SERVICE BULLETIN

from: TRIO-KENWOOD COMMUNICATIONS, INC.

SUBJECT: SERVICE NOTES ON TS-700A

SUBJECT: Model TS-700A

Replacement of 9V regulator IC
MFC-4060 with improved MC1723CL-A

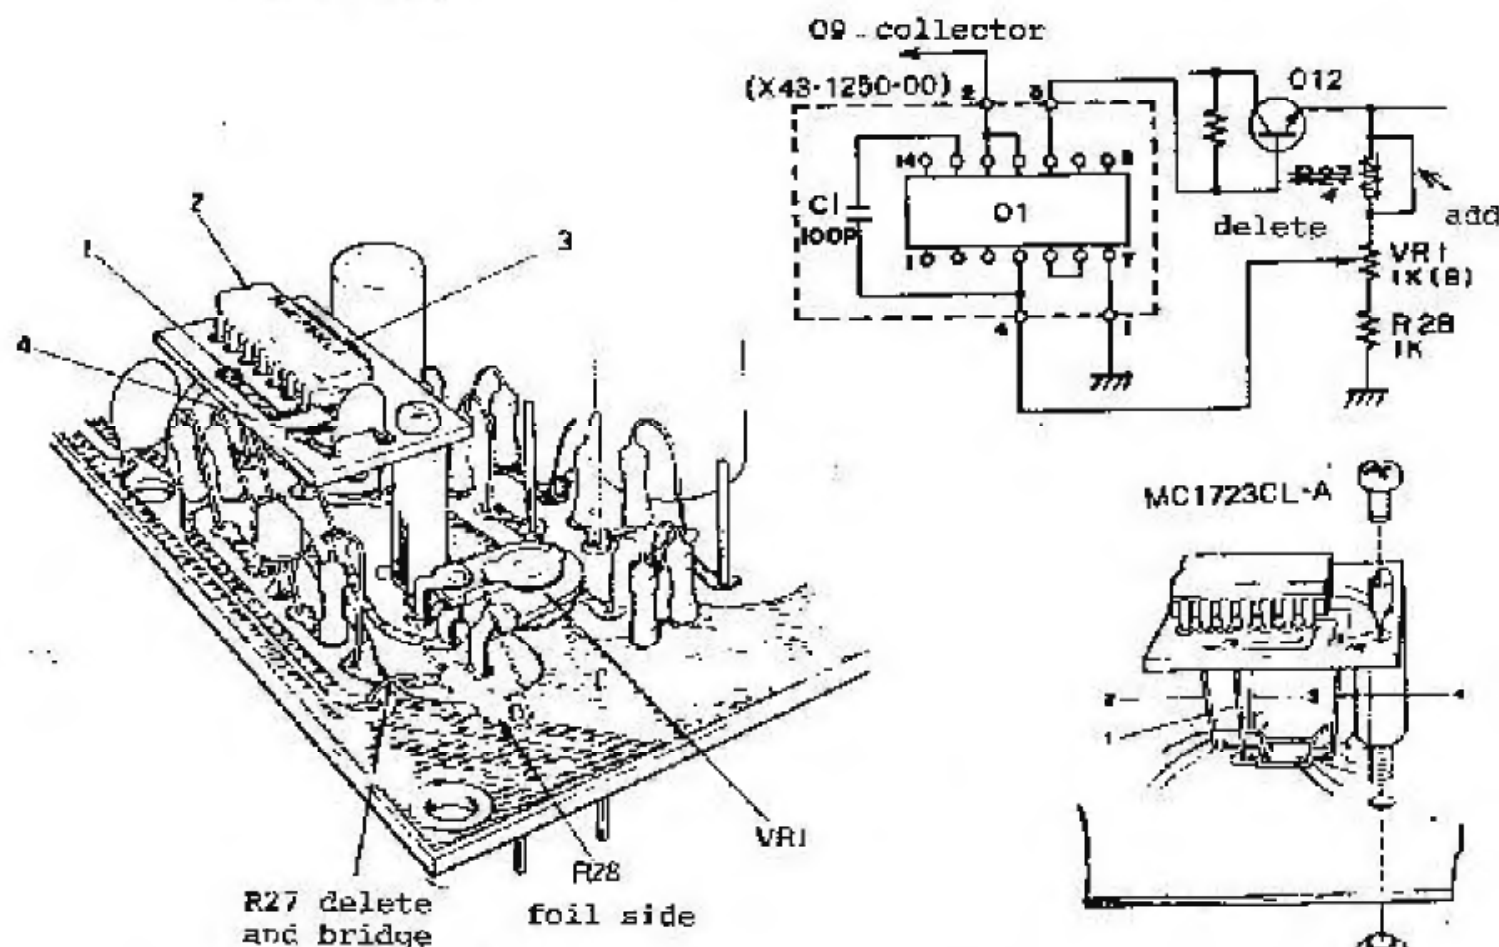
X43-1250-00 P.C.B. Comes complete with mounting hardware and extended leads for easy installation.

1. Remove old IC MFC4060-A Q11
2. Remove R27 1.5kohm (delete,). Replace with wire jumper.
3. Remove and reinstall R28 1kohm on foil side of P.C.B.
4. Mount P.C.B. per illustrations (observe lead call-outs between X43-1250-00, new P.C.B., and old Q11 position (X43-1120-00)).
5. Reset VR1 for 9.0V measured at power supply output terminal.
6. Reset VR2 for 21.0V measured at power supply output terminal.
